Addendum Number: 01

Addendum Issue Date: April 17, 2025

Project Name: Robinson Washington Elementary
Renovation & Addition

Project Number: 02401781.001

ENLARGED VENTILATION FLOOR PLAN - AREA E

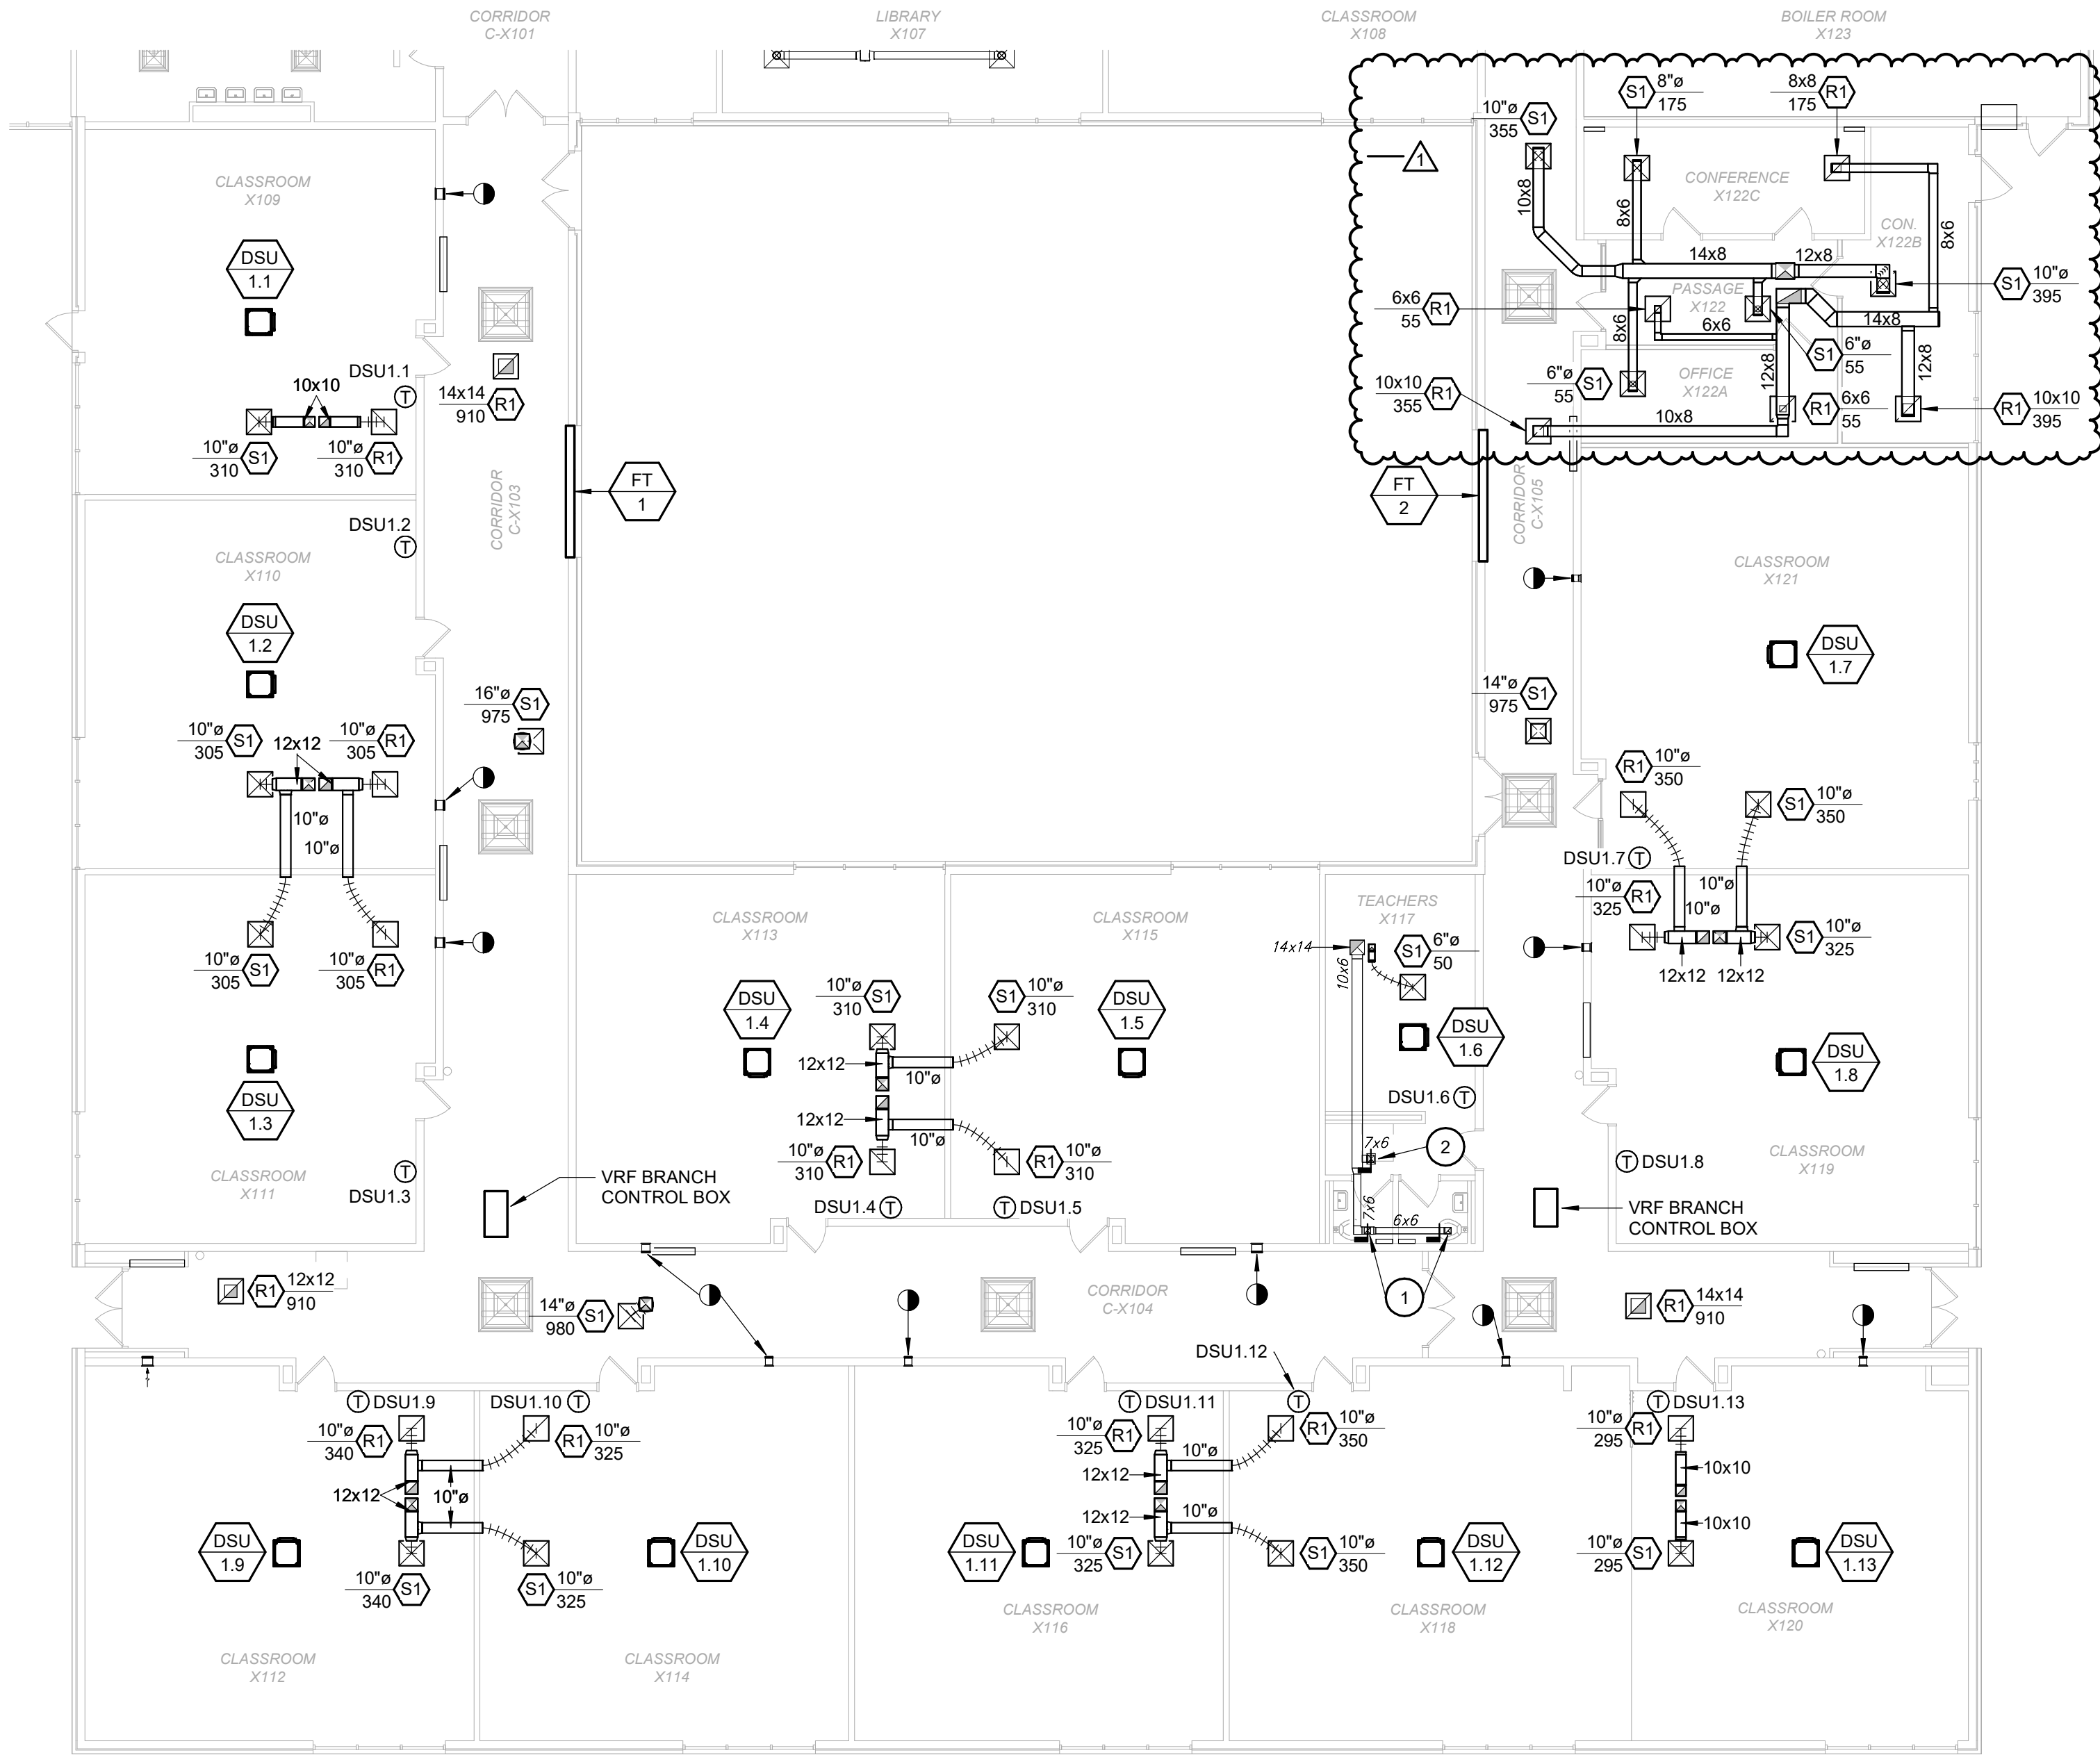
- a. REVISE RTU-1 ductwork serving X122, X122A, X122B, X122C, and C-X105

1 ENLARGED MECHANICAL PIPING FLOOR PLAN - AREA A
SCALE: 1/8" = 1'-0"

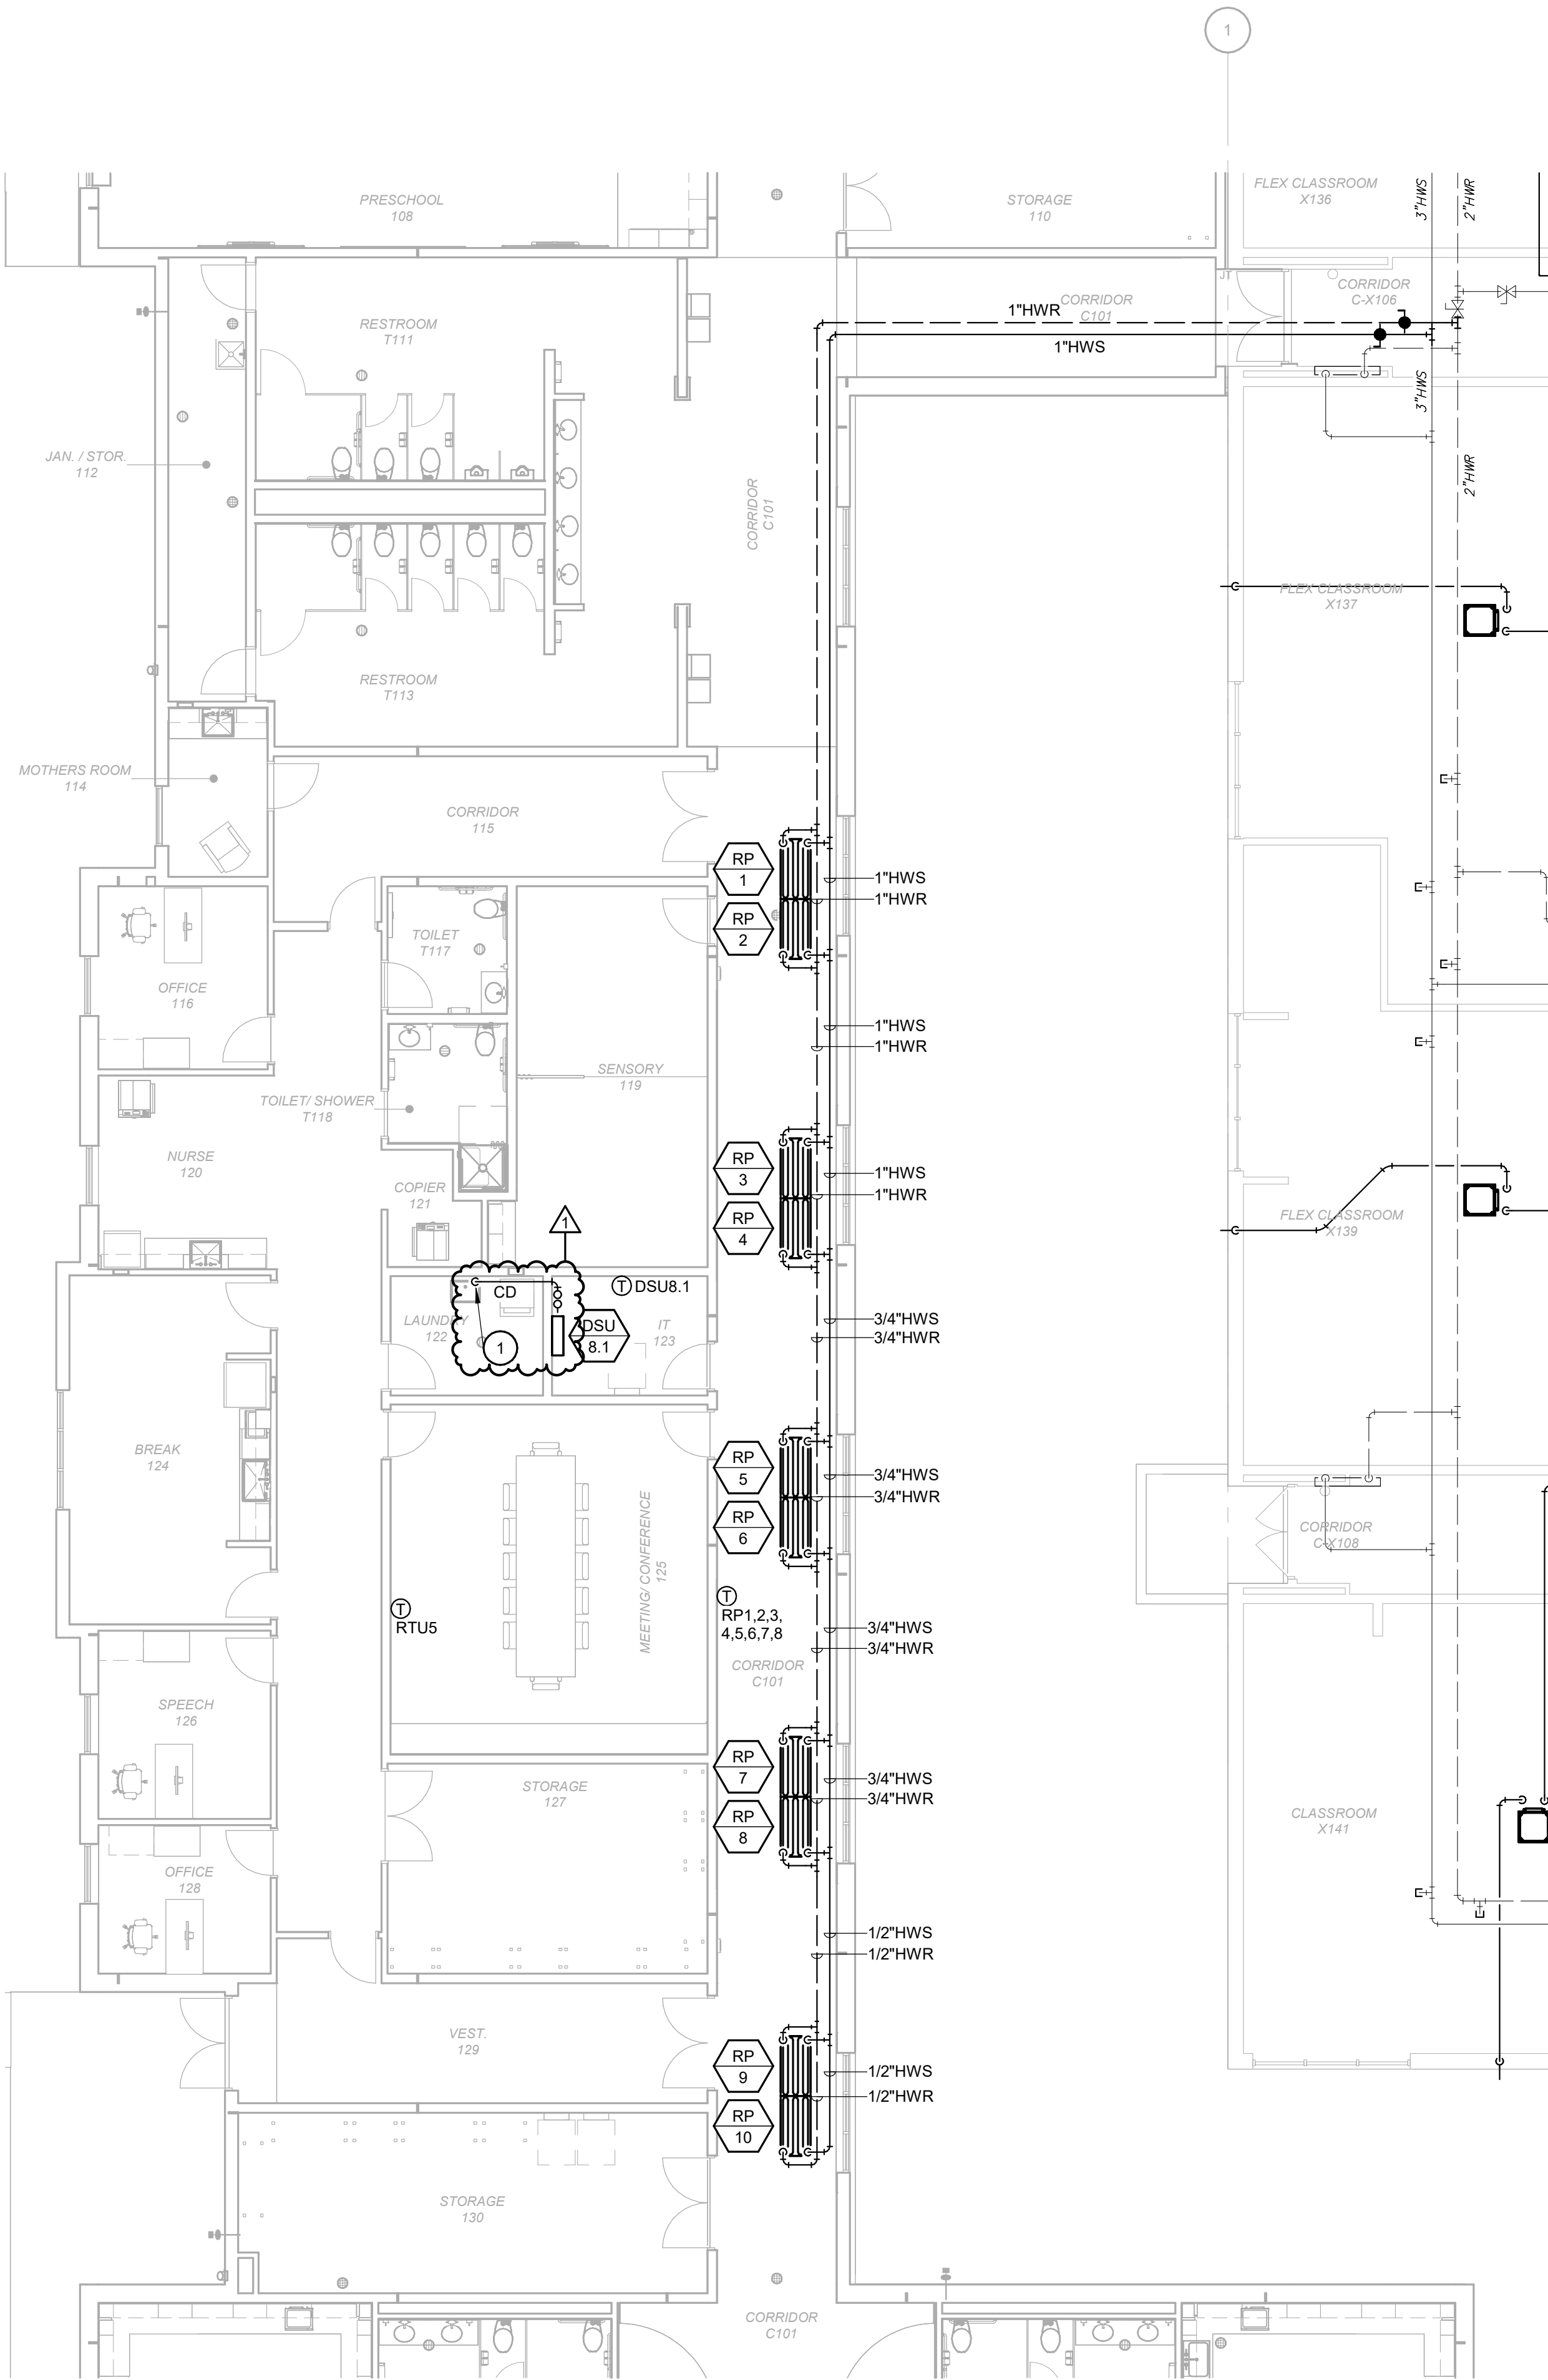
- a. ADD condensate drain piping
- b. ADD Keynote #1

ENLARGED MECHANICAL PIPING FLOOR PLAN - AREA D

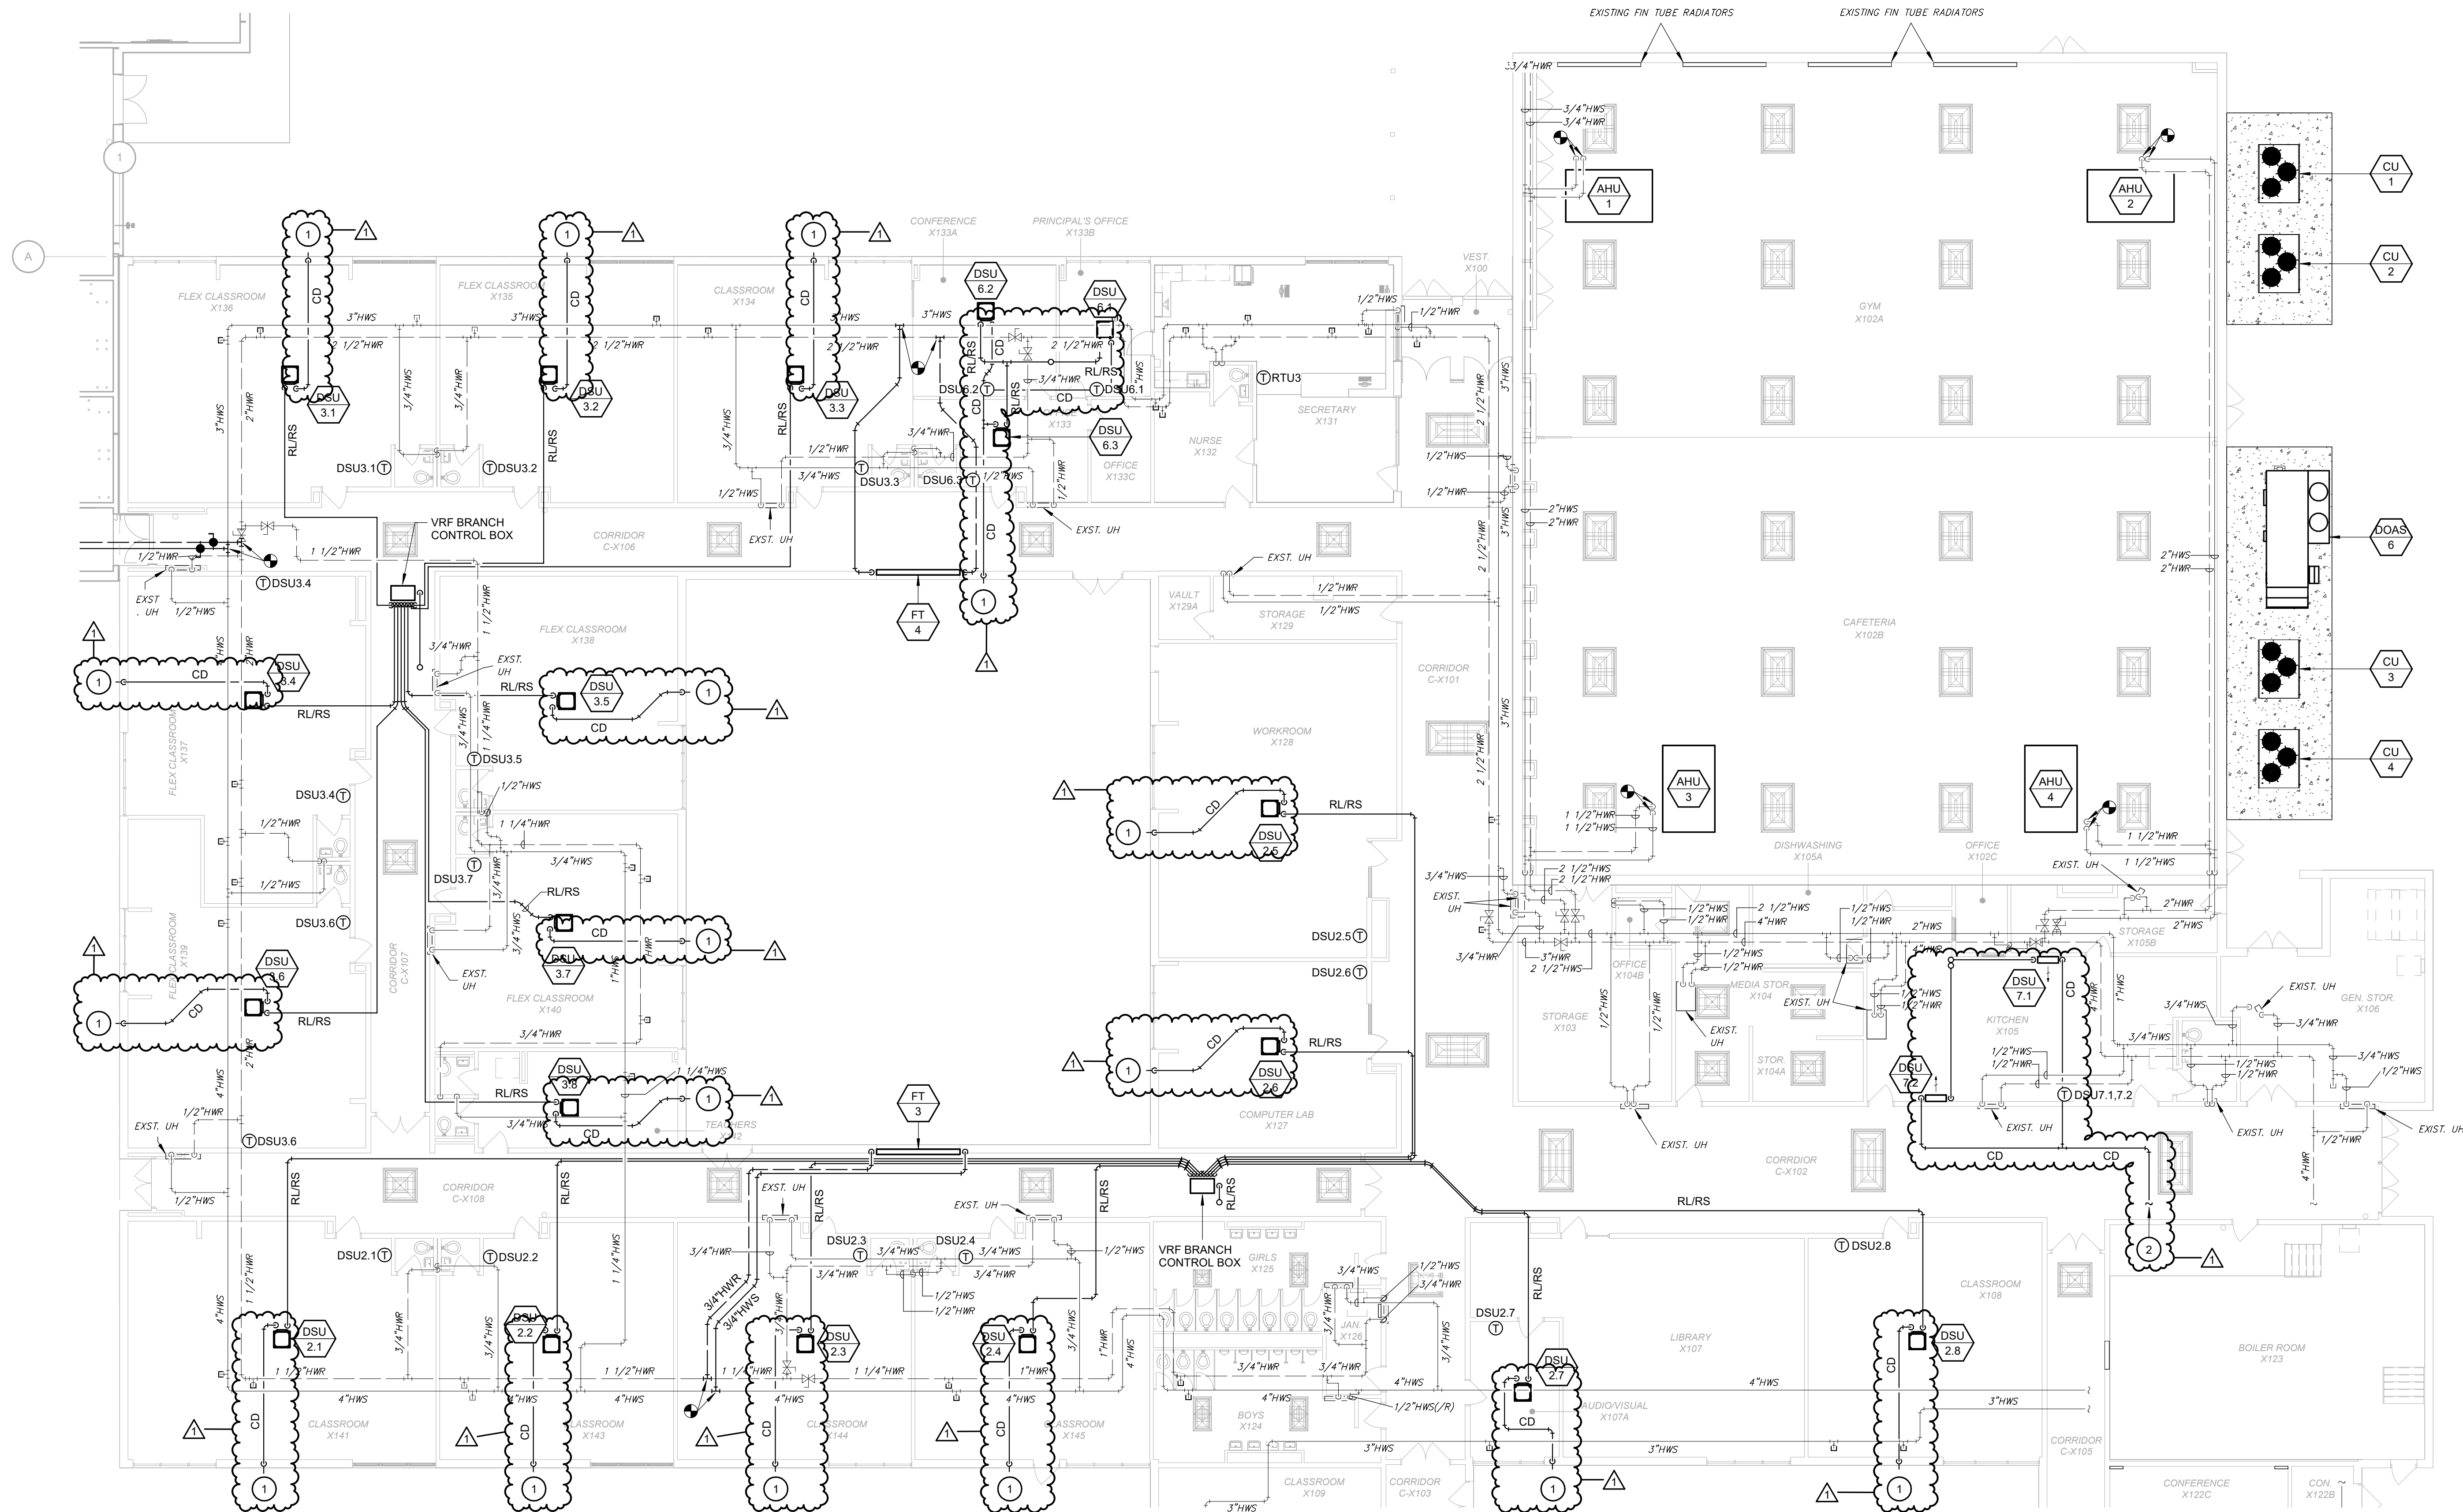
- a. ADD condensate drain piping
 - b. ADD Keynotes #1, #2
38. M2.1E – ENLARGED MECHANICAL PIPING FLOOR PLAN – AREA E
- a. ADD condensate drain piping
 - b. ADD Keynote #1
